Village of Arlington Heights
Conceptual Plan Review Committee
Community Room, 3rd Floor
Arlington Heights Village Hall
33 S. Arlington Heights Road
Arlington Heights, IL 60005
January 24, 2018
6:30 PM

Item: Sigwalt Apartments - 45 S. Chestnut Ave. - T1617

VILLAGE OF ARLINGTON HEIGHTS STAFF DEVELOPMENT COMMITTEE REPORT

Project Title: Sigwalt Street Apartments

Site Plan

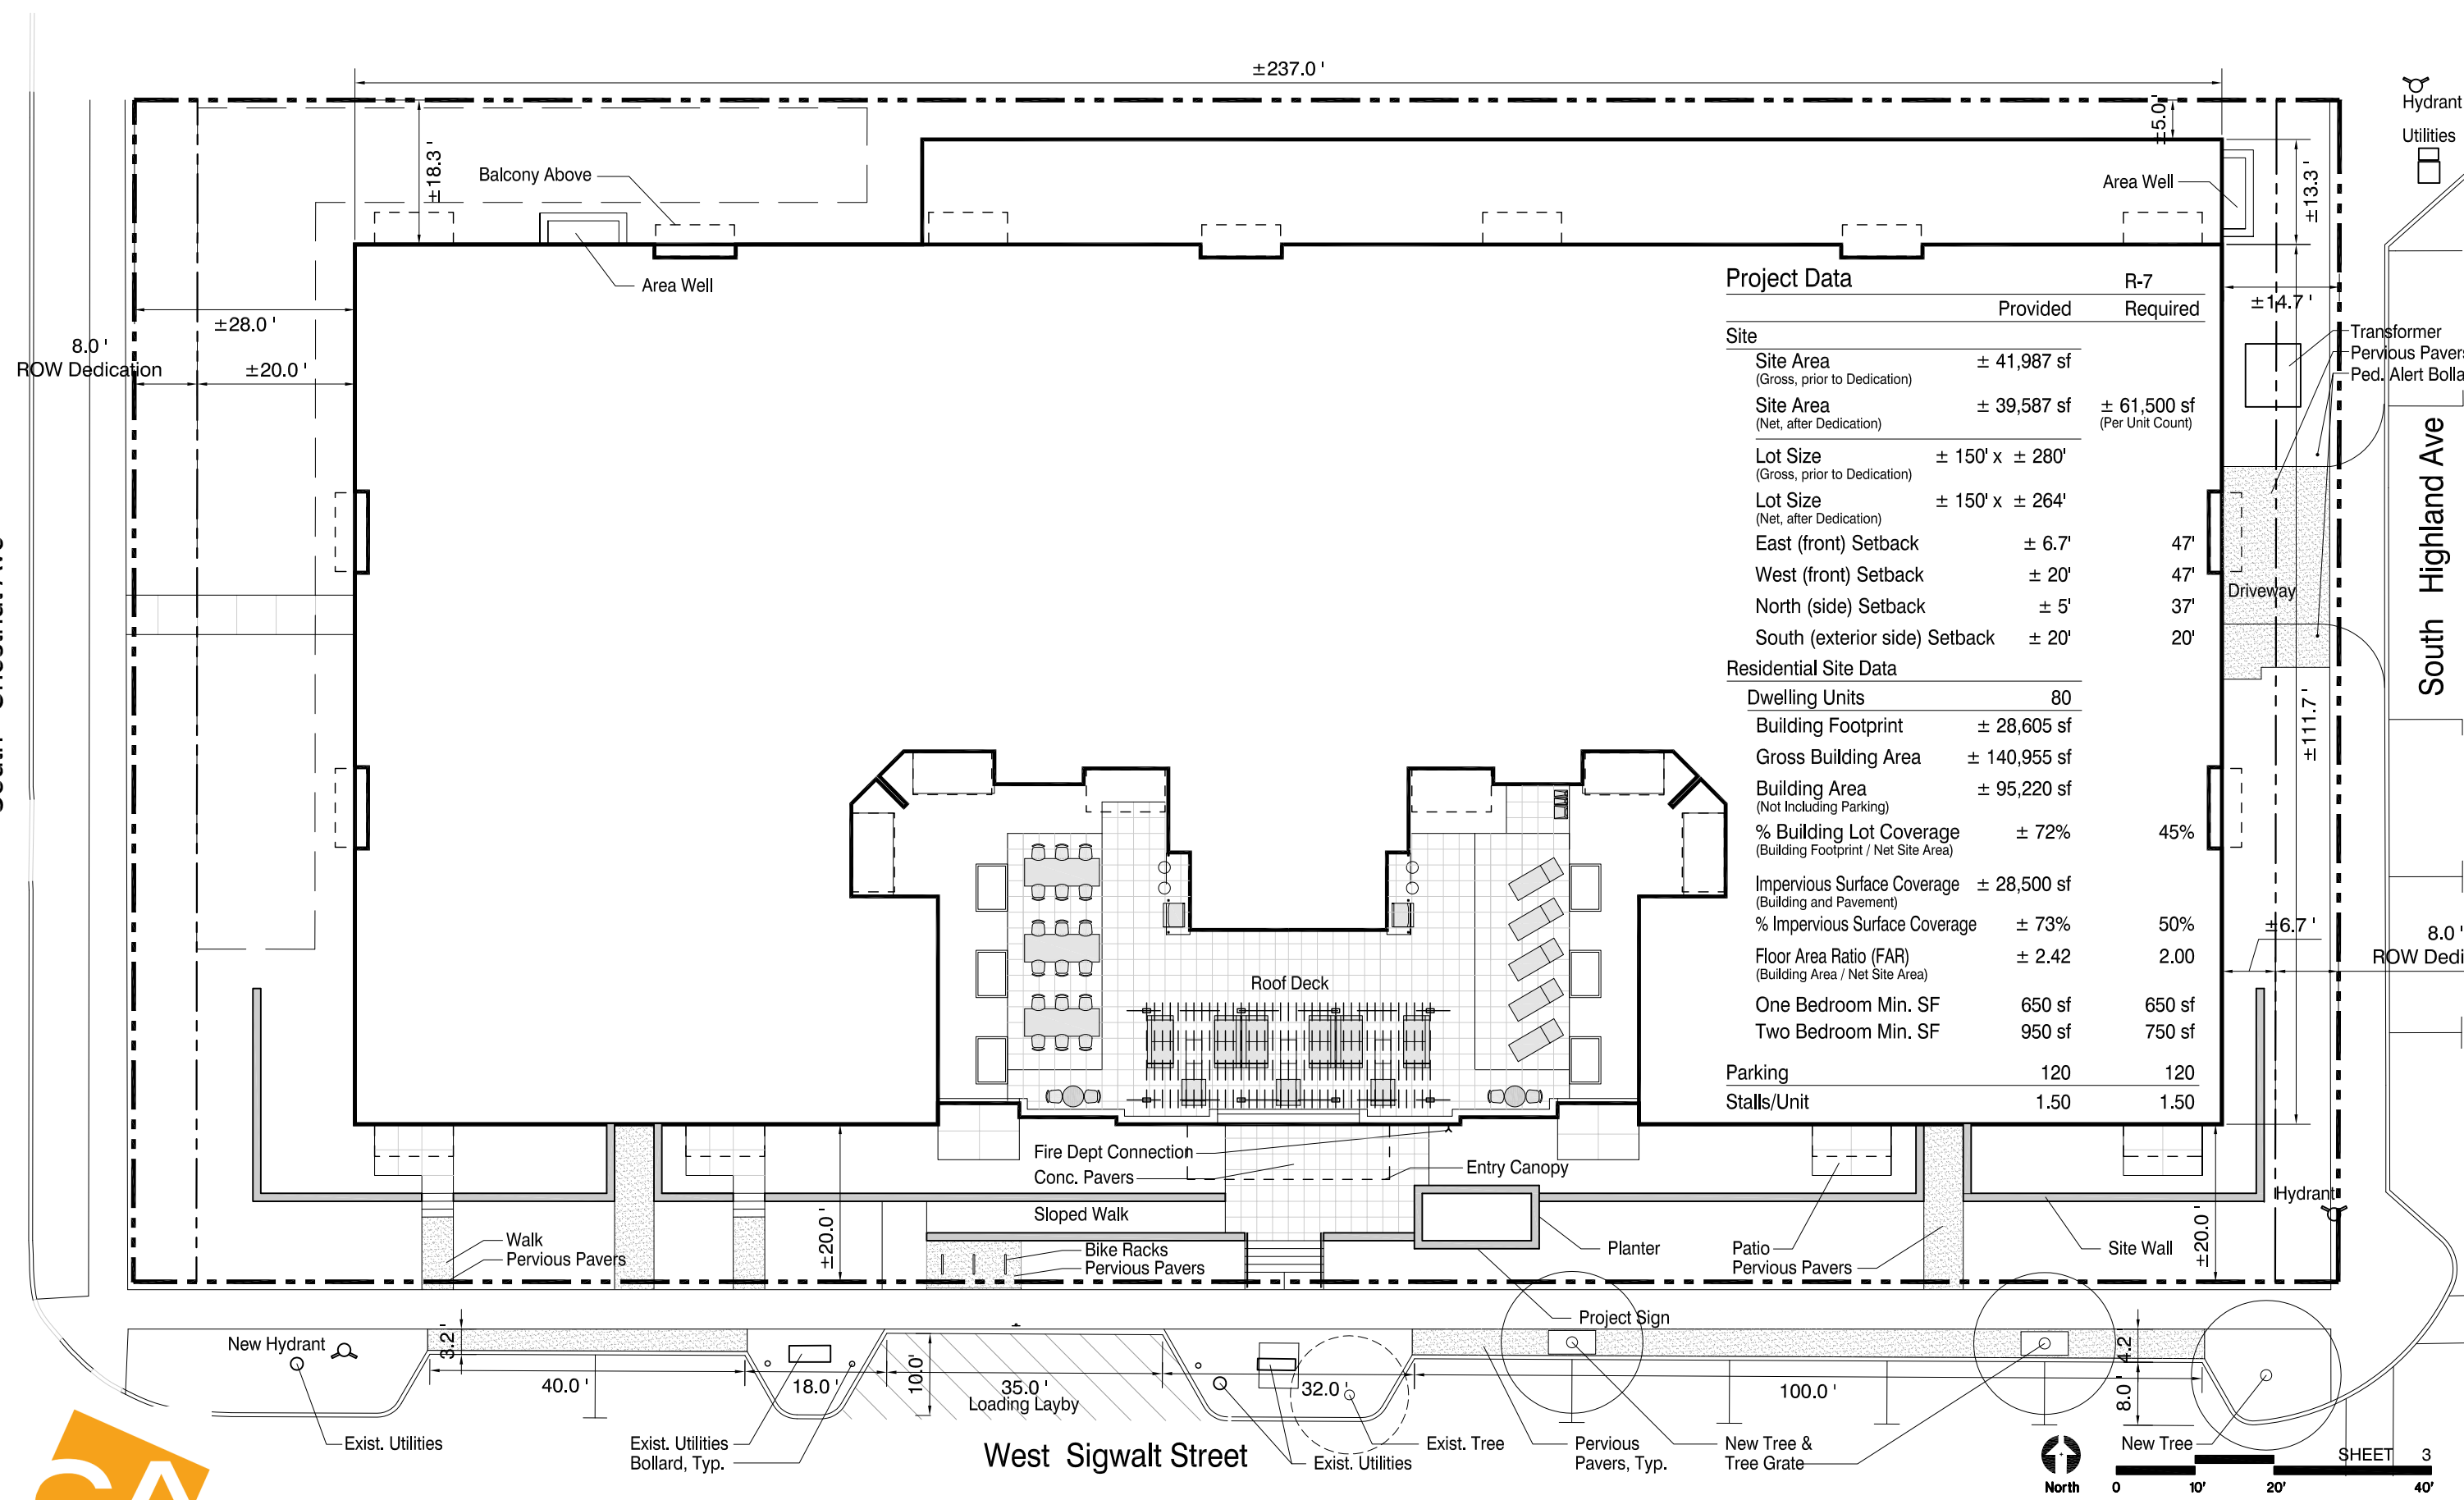
As indicated above, the location of the building on the subject property has been shifted slightly to the east in an effort to increase the separation between the structure and the single-family residential neighborhood to the west. This shift has decreased the east setback from the previously proposed distance of 10.5 feet to a distance of 6.8 feet, which allowed them to shift the building to the east. The western setback therefore

increased from 16.3 feet to 20 feet (after 8-foot Right-of-way dedication), providing more separation between the structure and single-family homes along Chestnut Avenue.

The building has been narrowed on the southern side to provide a 20-foot setback along Sigwalt Street, which now complies with the code required 20-foot setback along this elevation and eliminates the need for a setback variation. Additionally, the density of the building has been reduced from 88 units to 80 units; code allows a maximum of 53 units based on the proposed unit mix. The F.A.R. has also been reduced from the originally proposed 253% F.A.R. to a revised F.A.R. of 242%. Finally, in response to concerns over the height and bulk of the structure, the developer has proposed a recessed fifth floor, which will help to soften the mass of the building when viewed from the street. On the Sigwalt Street side, the fifth floor has been recessed 13 feet from the southern face of the building. On the Highland and Chestnut Avenue sides, the fifth floor has been recessed 10 feet. On the north side, portions of the fifth floor at the corners have been recessed 10 feet from the northern edge of the building. In total, the developer has reduced the size of the fifth floor by 21%.

First Floor Plan

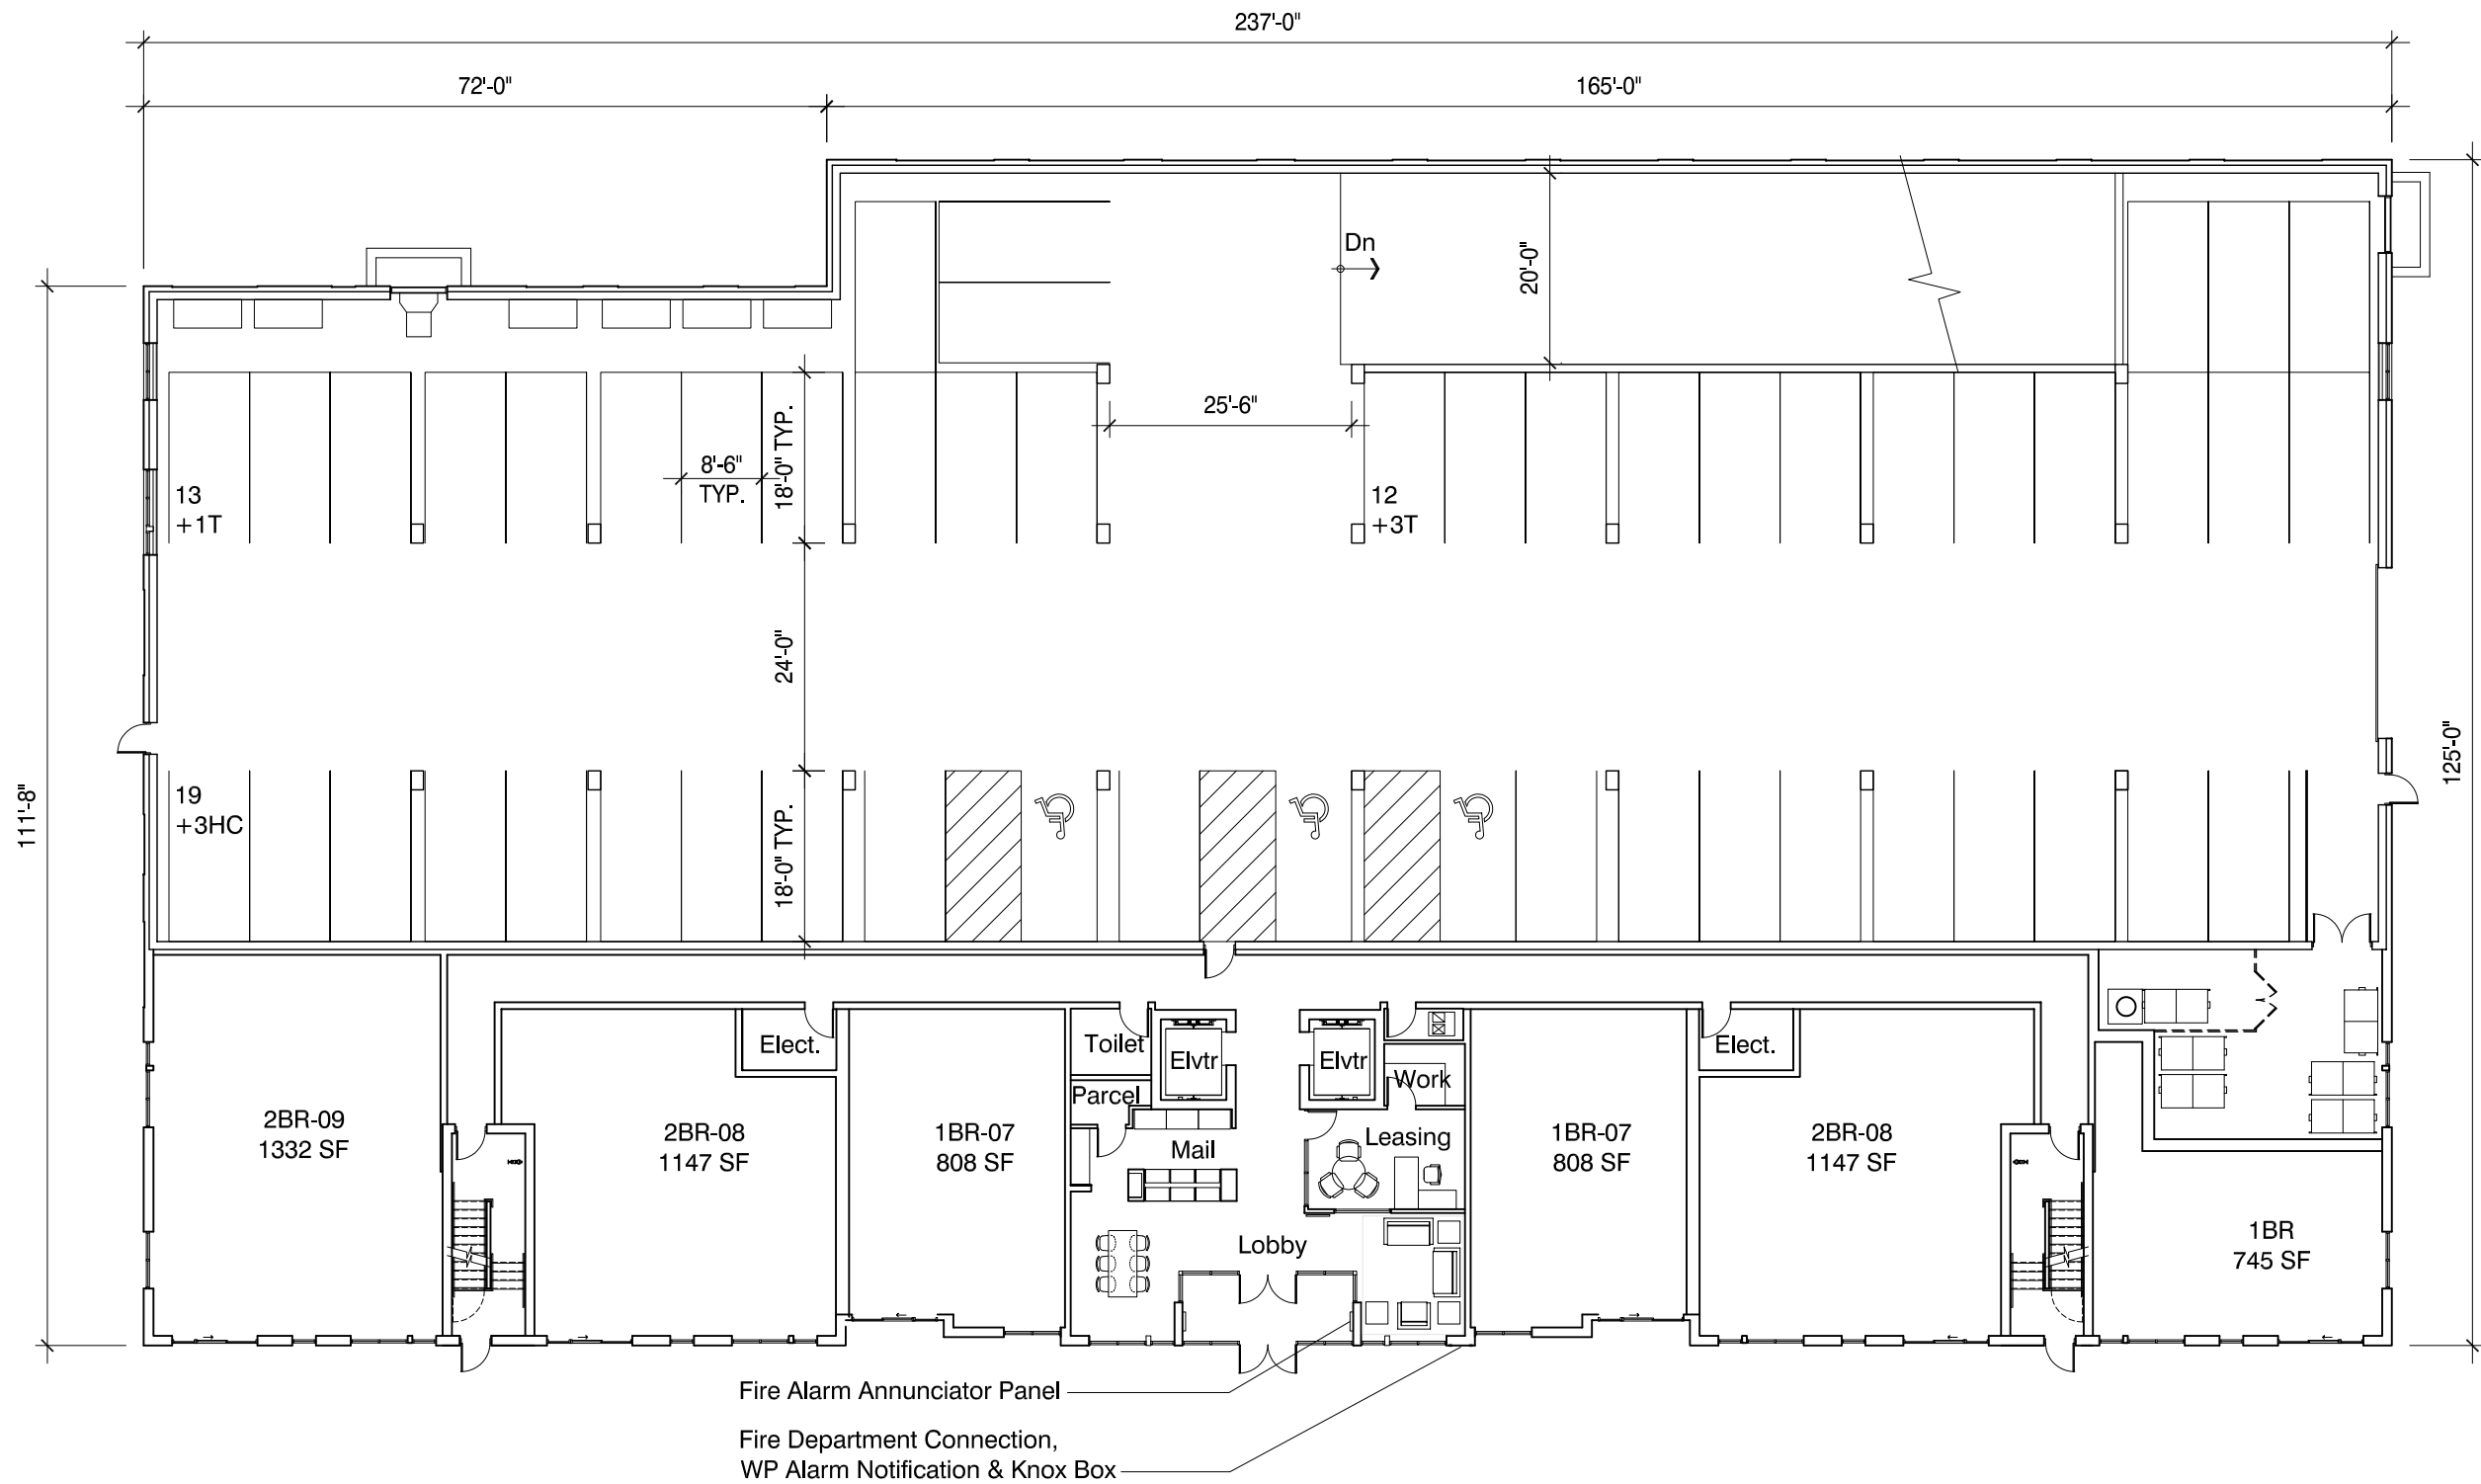
A total of 120 parking spaces are proposed within the basement and first floor garage levels. Of these spaces, 32 are tandem and 88 are standard parking spaces. The length of the parking spaces has been extended to provide the full 18-foot depth as required by code, which eliminates the need for one of the previously requested variations. Due to the constrained nature of interior parking garages, a variation is still required to allow a drive aisle width of 20 feet where code requires a 24-foot wide drive aisle.
